Site Stabilization Work Plan -

Former East Alcoa Property

June 30, 2023

Geo-Technology Associates, Inc. (GTA), on behalf of Quantum Maryland LLC, has prepared the following Work Plan for site stabilization activities at the Former East Alcoa Property (“Site”). These activities are proposed to address concerns transmitted by the Water and Sciences Administration.

Figure 1

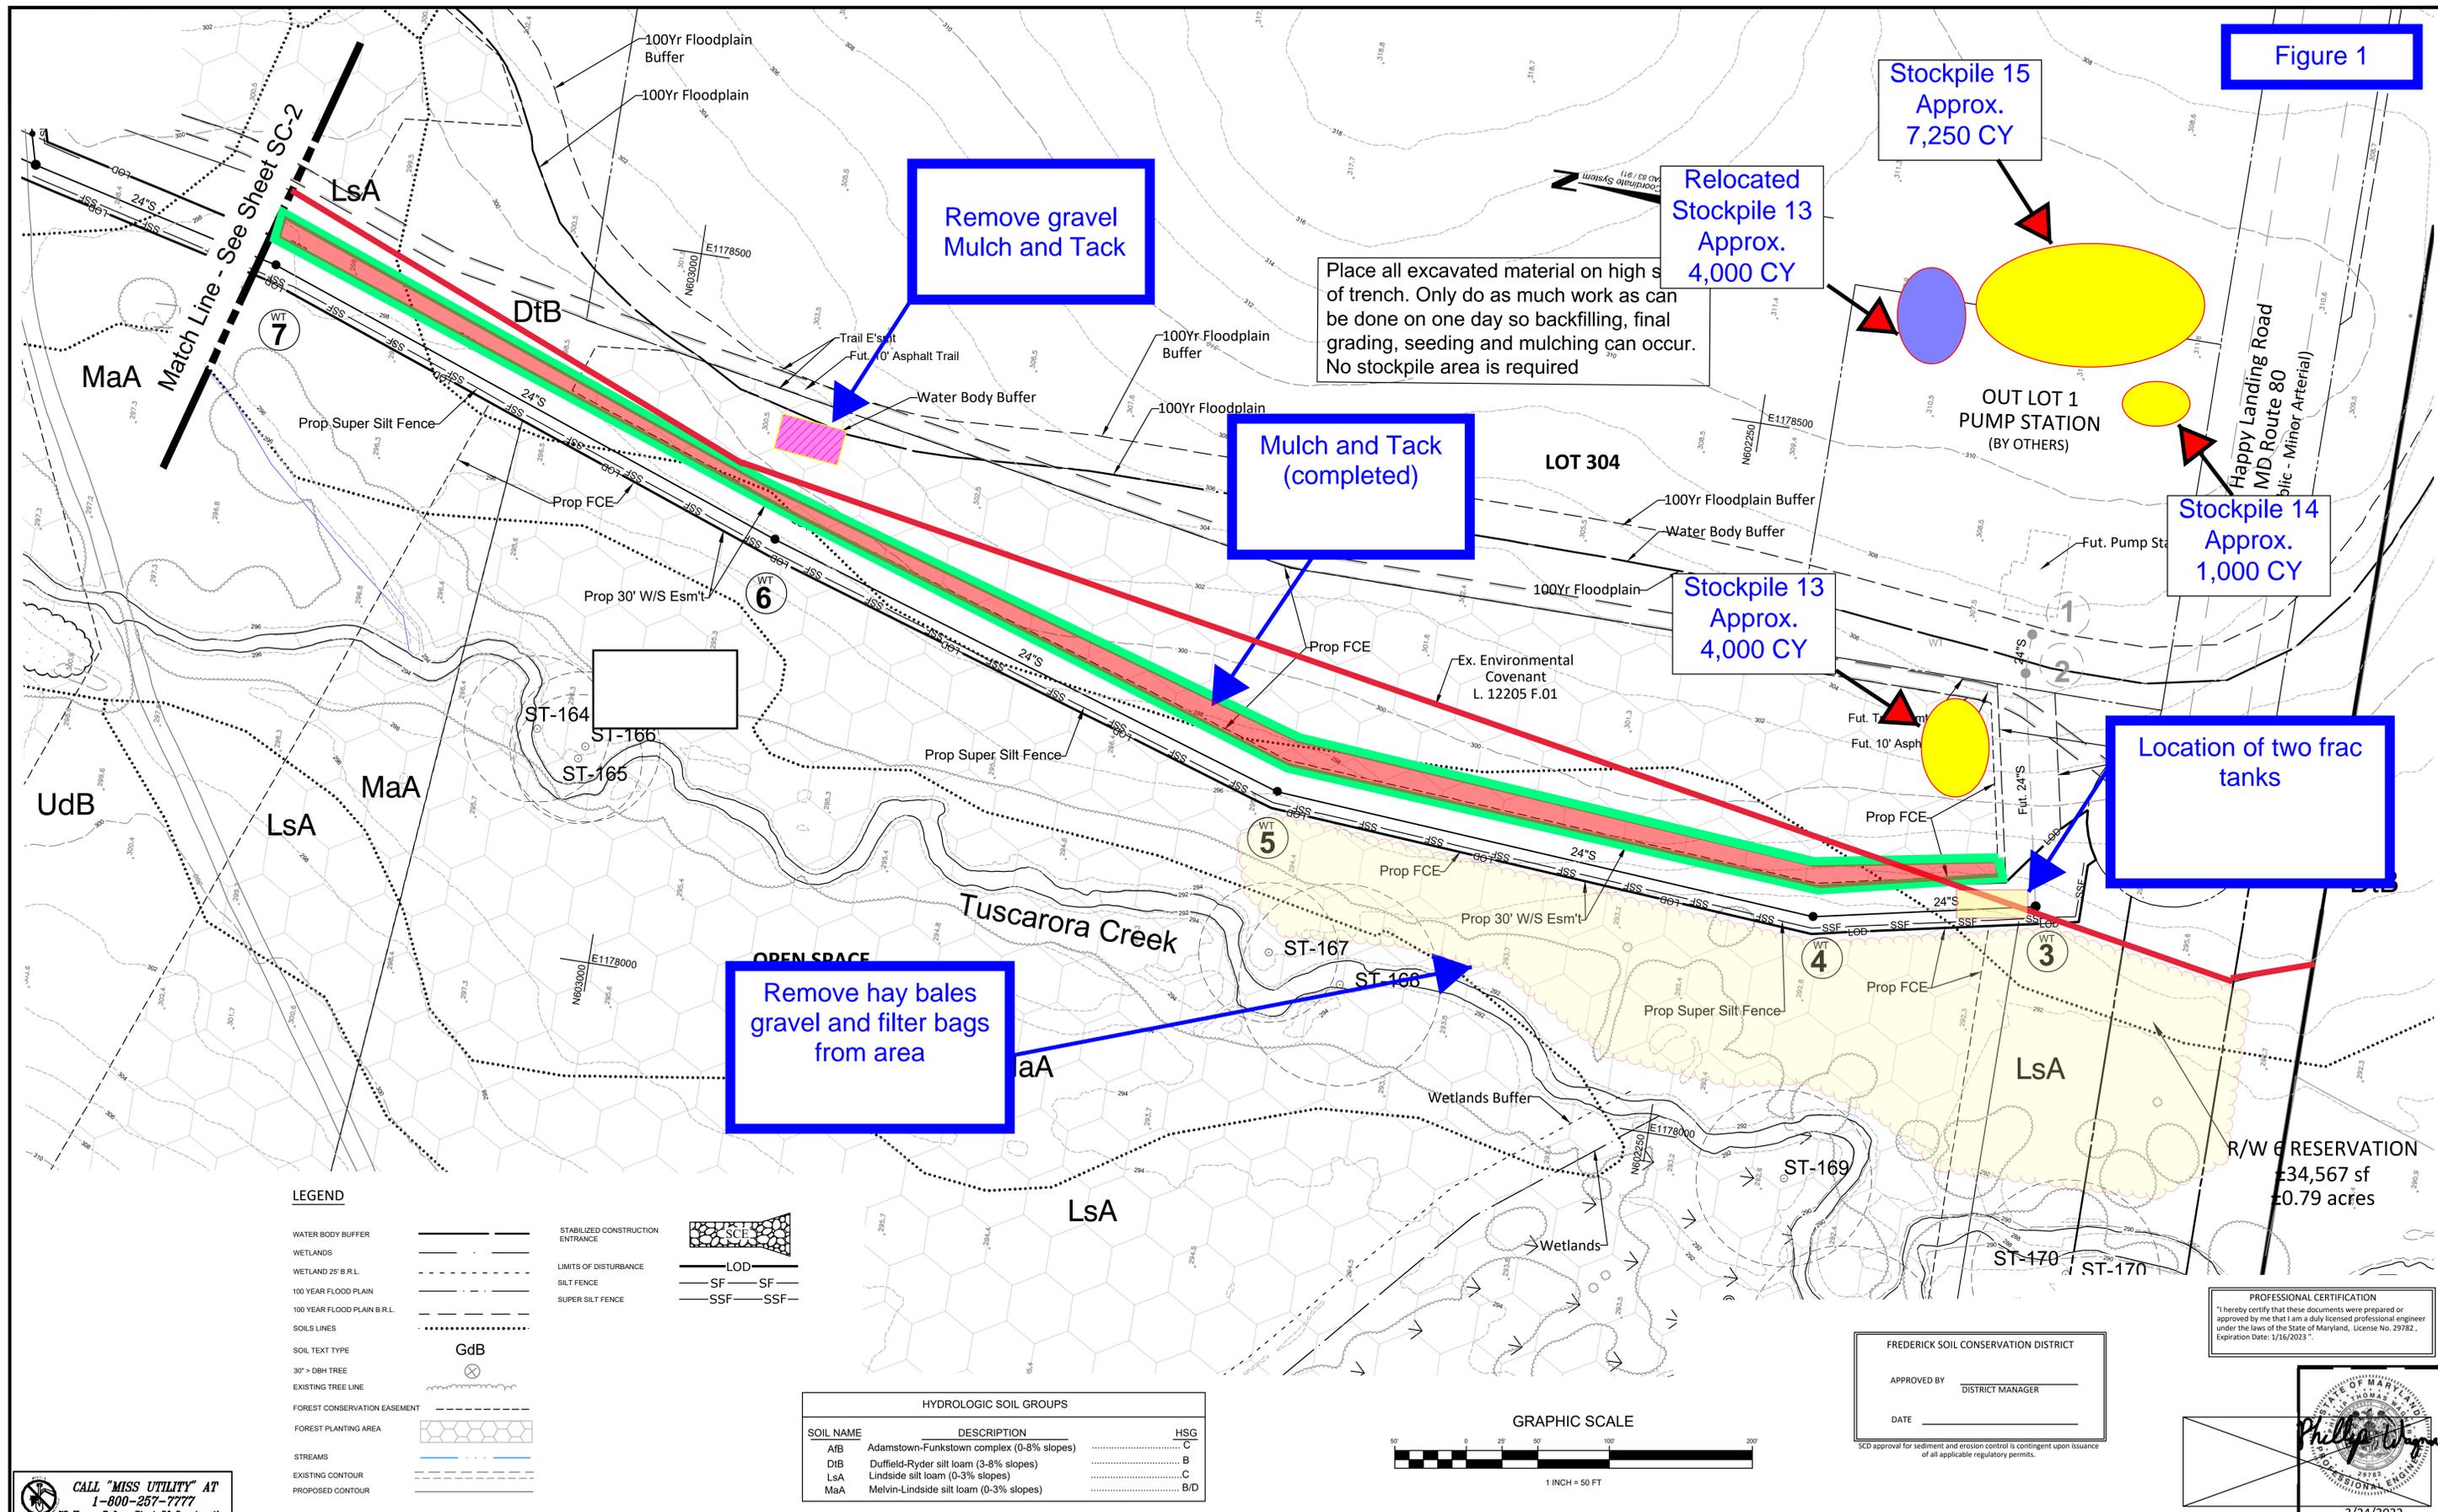
Floodplain Gravel and Straw Bale Removal – Gravel, filter bags, and straw bales are to be removed from the portions of the floodplain located outside of the LOD. These areas are primarily located west of MH-3 and MH-5, and east of MH-6 (see Figure 1).

Work associated with the area west of MH-3 and MH-5 is anticipated to take approximately 1½ days and would involve the use of a dump truck and a skid steer. Hay bales, gravel, and filter bags are to be removed by hand, placed into the skid steer, then loaded into a dump truck. Removed materials are to be relocated to a temporary storage area along the proposed Happy Landing Road, within the LOD and outside of the floodplain (see Figure 5). A hydroseeder will be utilized to stabilize the area after work is completed. (Personnel: 1 Operator, 1 Drivers, 2 Laborers)

Figure 4

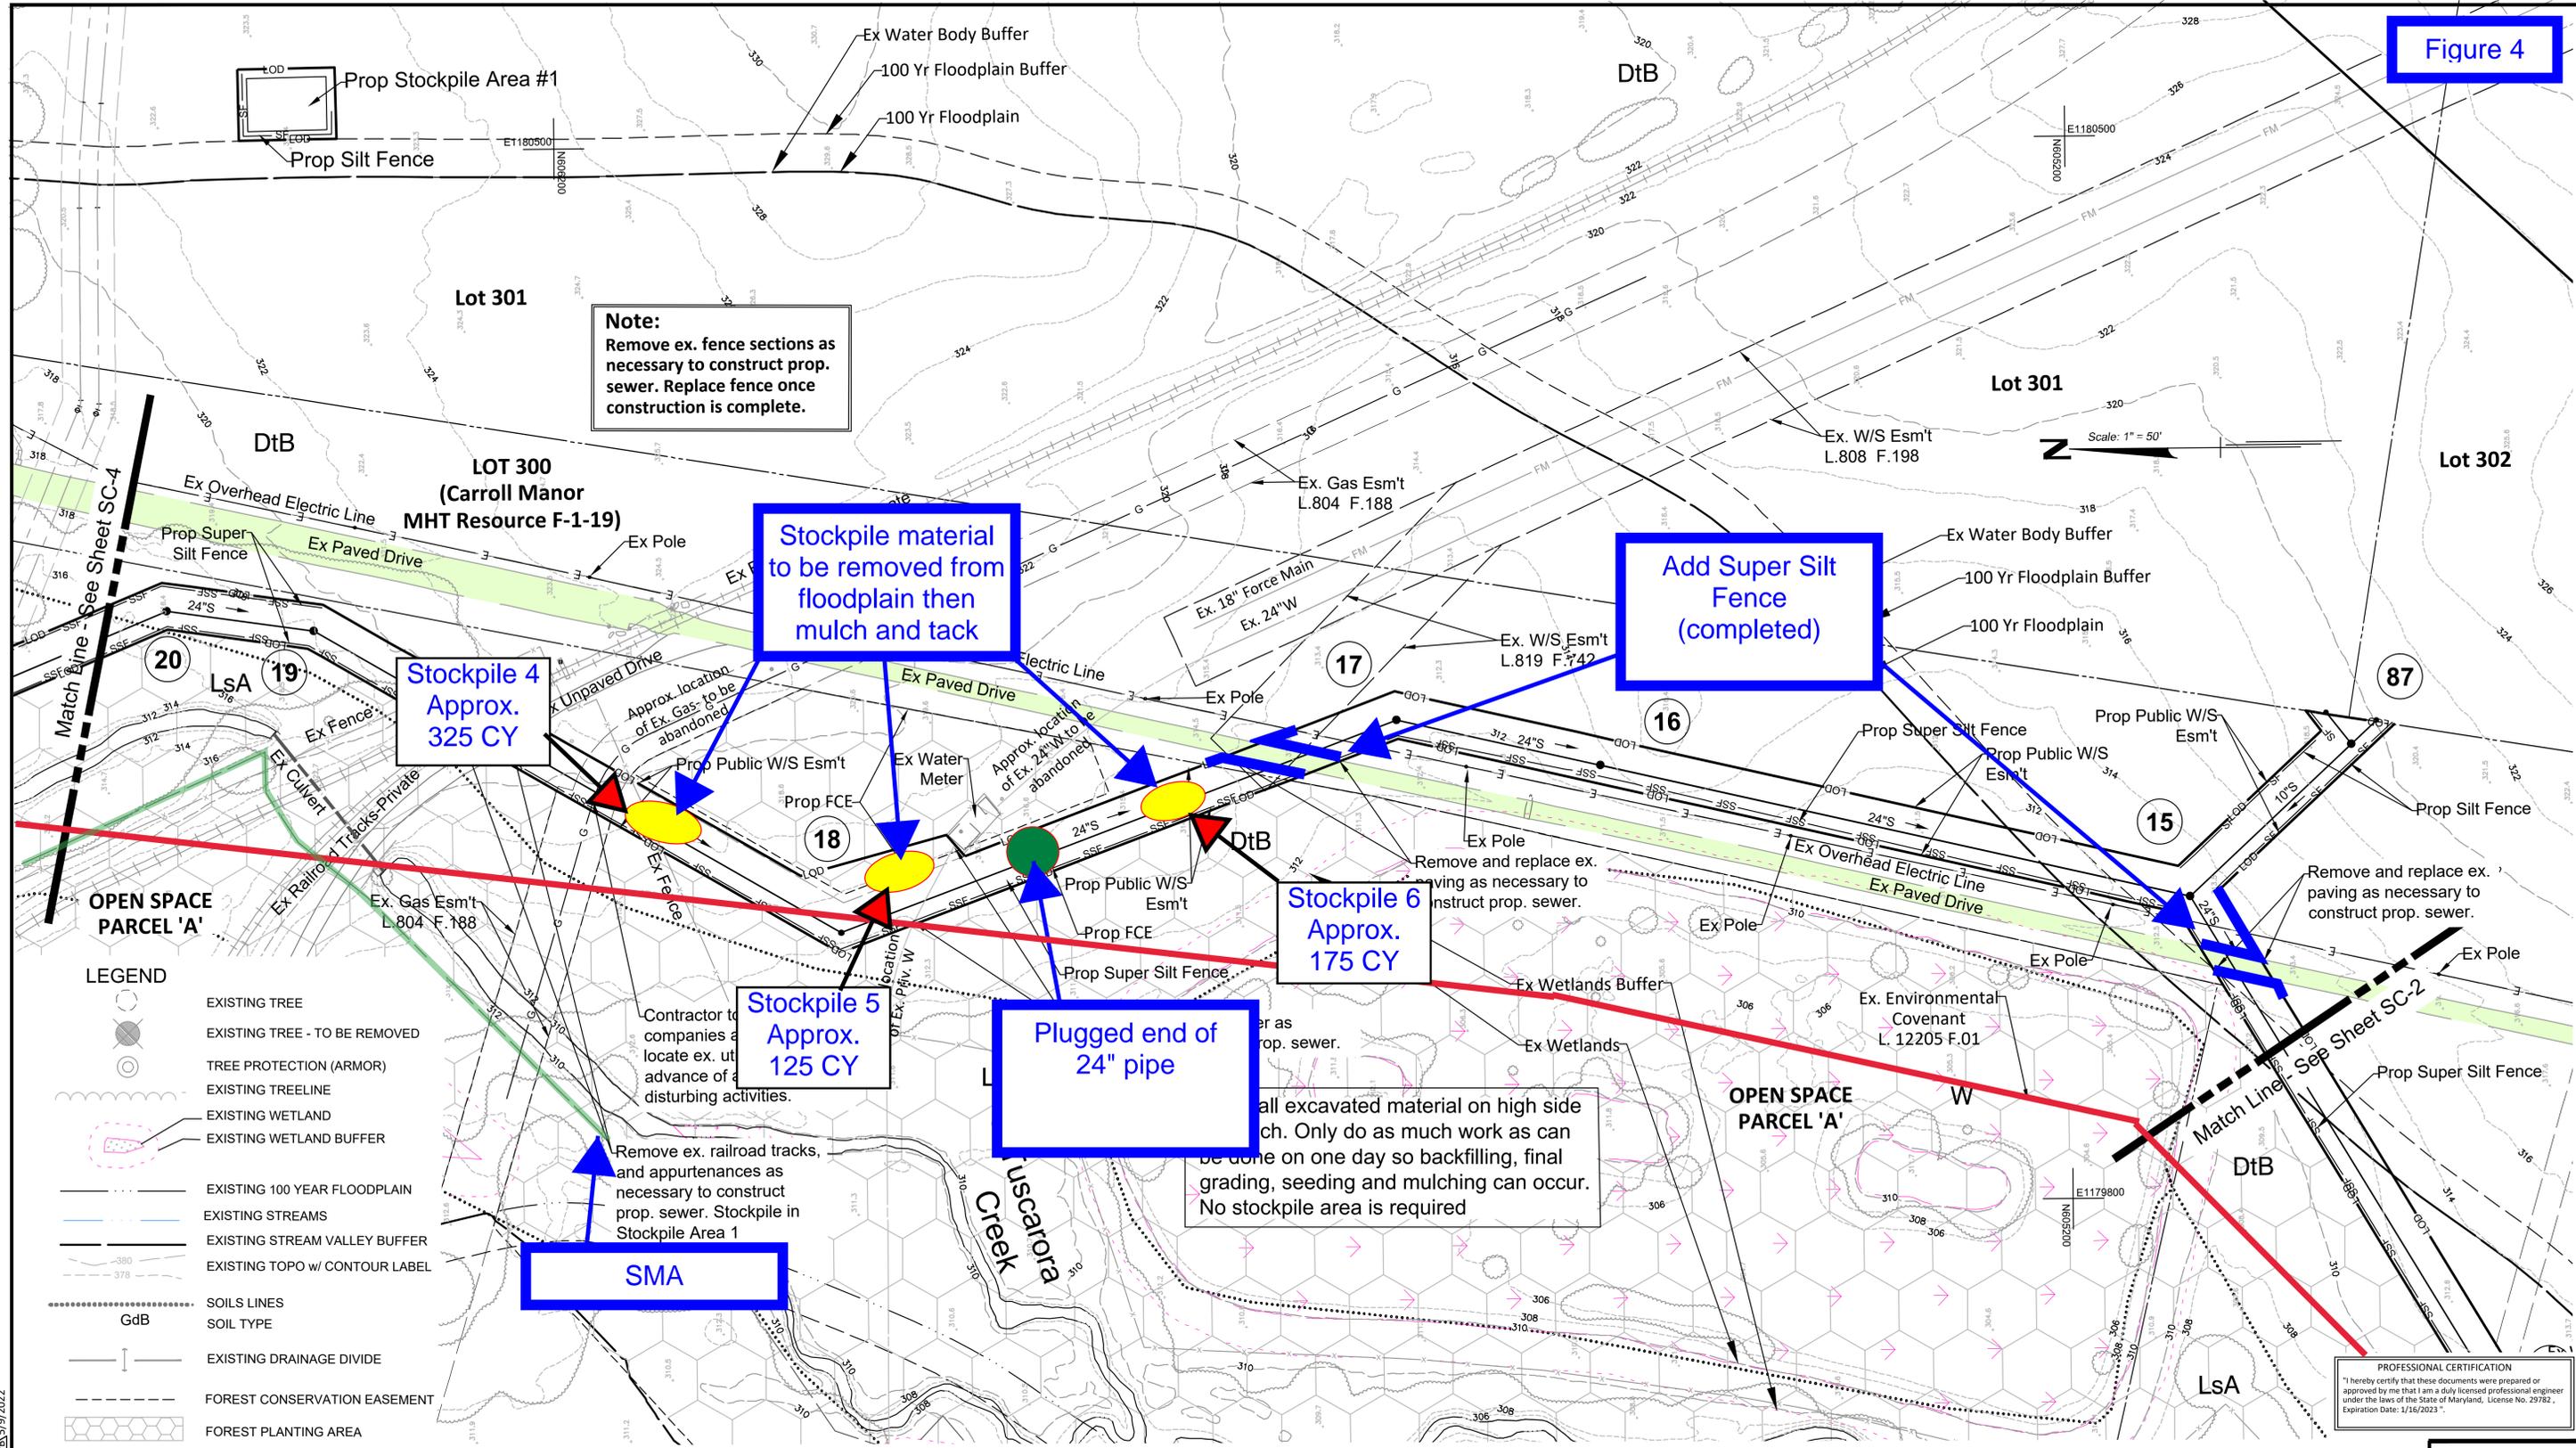
Stockpile material to be removed from floodplain then mulch and tack

Add Super Silt Fence (completed)

**Stockpile 4
Approx. 325 CY**

**Stockpile 6
Approx. 175 CY**

**Stockpile 5
Approx. 125 CY**
